Technical Service Bulletin

SUBJECT:			No: TSB-19-52B-001
UPDATES TO REMOVAL & INSTALLATION OF SEAT BELTS WITH PRE-TENSIONER - SMR			DATE: February 2019
			MODEL: See below
CIRCULATE TO:	<input type="checkbox"/> GENERAL MANAGER	<input checked="" type="checkbox"/> PARTS MANAGER	<input checked="" type="checkbox"/> TECHNICIAN
<input checked="" type="checkbox"/> SERVICE ADVISOR	<input checked="" type="checkbox"/> SERVICE MANAGER	<input type="checkbox"/> WARRANTY PROCESSOR	<input type="checkbox"/> SALES MANAGER

This TSB updates the Interior & Supplemental Restraint (SRS) section of the affected Service Manuals to update the Removal and Installation procedure of seat belts with pre-tensioner (seat belt anchor adjuster has been added).

Please make the indicated changes below to the 2014, 2015, 2017 Mirage and 2017 Mirage G4 Service Manuals, Group 52-Interior & Supplemental Restraint (SRS) -> 52B-Supplemental Restraint System (SRS) -> Seat Belts with Pre-Tensioner -> Removal and Installation:

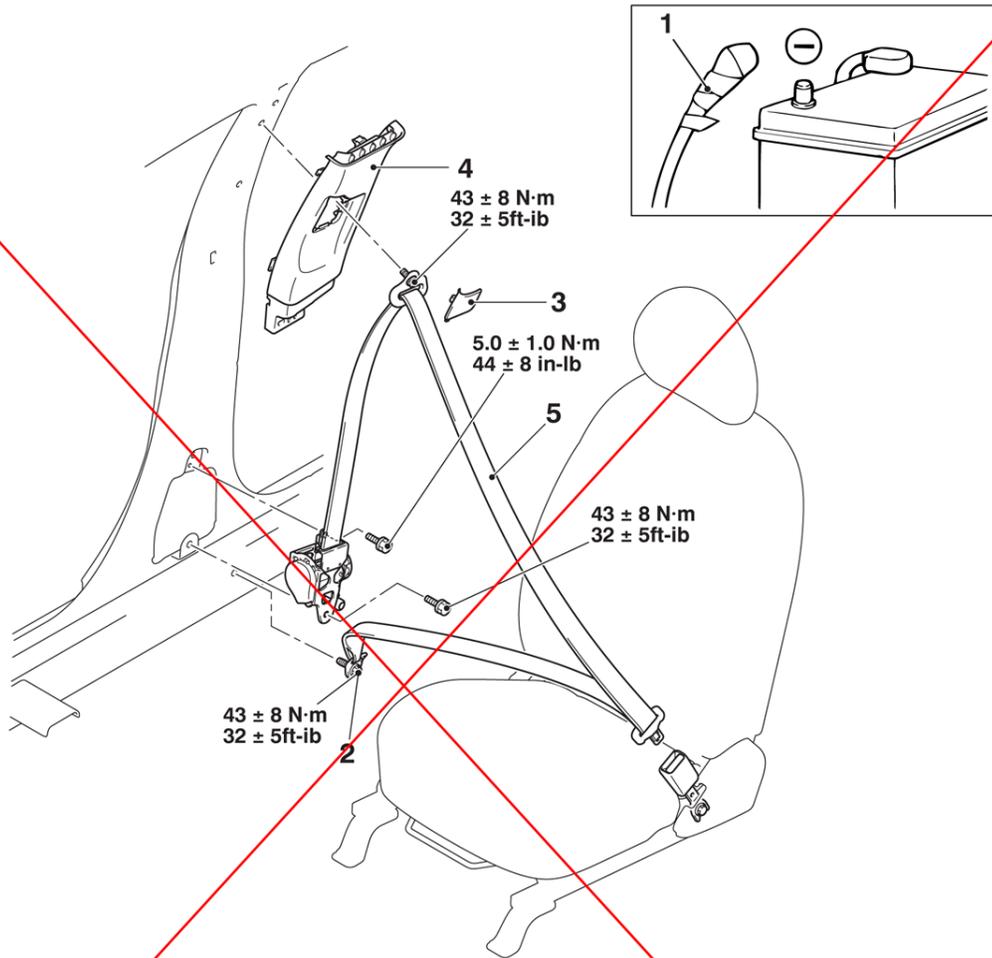
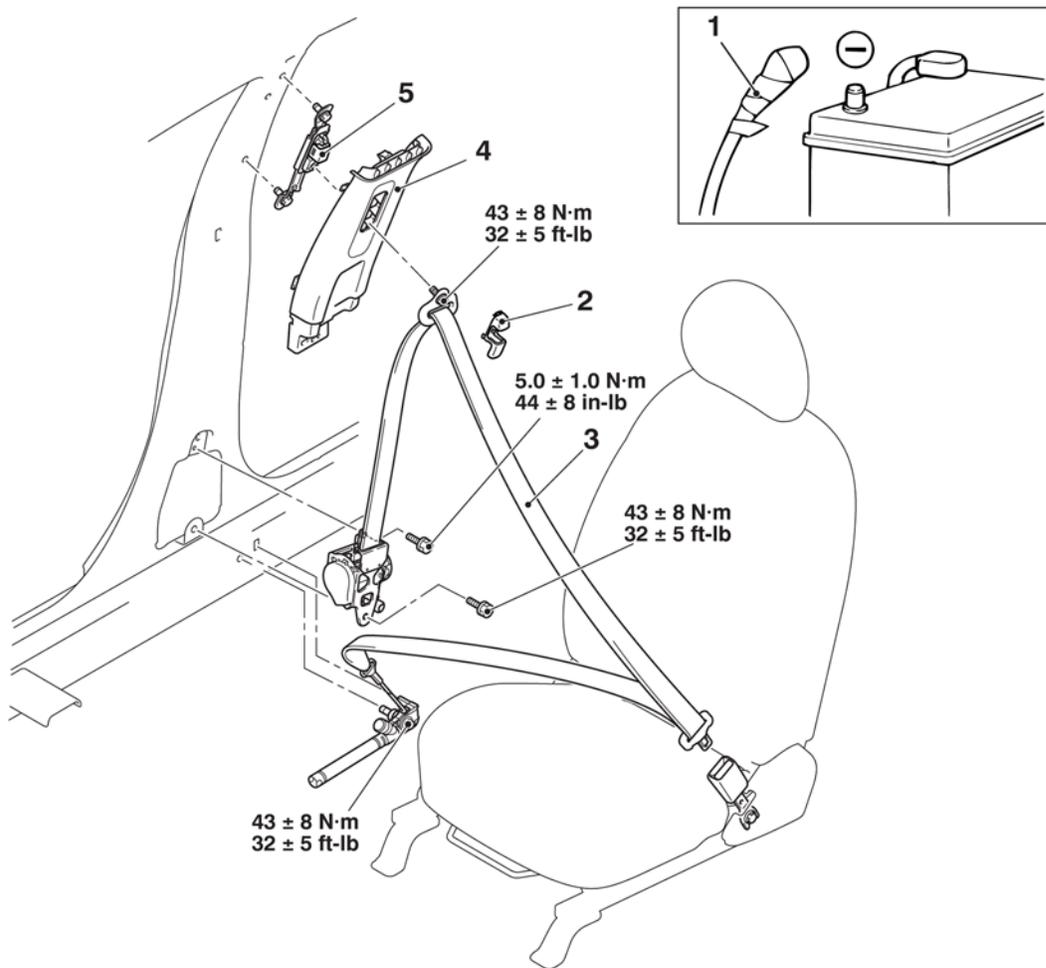
<Incorrect>

1. Negative (-) battery cable
 - Front scuff plate, scuff plate rear, center pillar trim lower (Refer to GROUP 52A – Interior Trim).
2. Outer seat belt mounting bolt
3. Center pillar trim upper cap
4. Center pillar trim upper (Refer to GROUP 52A – Interior Trim .)
5. Seat belt with pre-tensioner

- Pre-installation inspection
- 5. Seat belt with pre-tensioner
- 4. Center pillar trim upper (Refer to GROUP 52A – Interior Trim).
- 3. Center pillar trim upper cap
- 2. Outer seat belt mounting bolt
 - Front scuff plate, scuff plate rear, center pillar trim lower (Refer to GROUP 52A – Interior Trim).
- 1. Negative (-) battery cable
- Post-installation inspection

<Correct>

- <<A>>
- Removal steps**
1. Negative (-) battery cable
 - Front scuff plate, scuff plate rear, center pillar trim lower (Refer to GROUP 52A – Interior Trim).
- <>
2. Front seat belt sash cover
 3. Seat belt with pre-tensioner
 4. Center pillar trim upper (Refer to GROUP 52A – Interior Trim .)
 5. Front seat belt anchor adjuster

- >>A<<
- Installation steps**
- Pre-installation inspection
 - 5. Front seat belt anchor adjuster
 - 4. Center pillar trim upper (Refer to GROUP 52A – Interior Trim).
 - 3. Seat belt with pre-tensioner
 - 2. Front seat belt sash cover
 - Front scuff plate, scuff plate rear, center pillar trim lower (Refer to GROUP 52A – Interior Trim).
- >>B<<
1. Negative (-) battery cable
 - Post-installation inspection
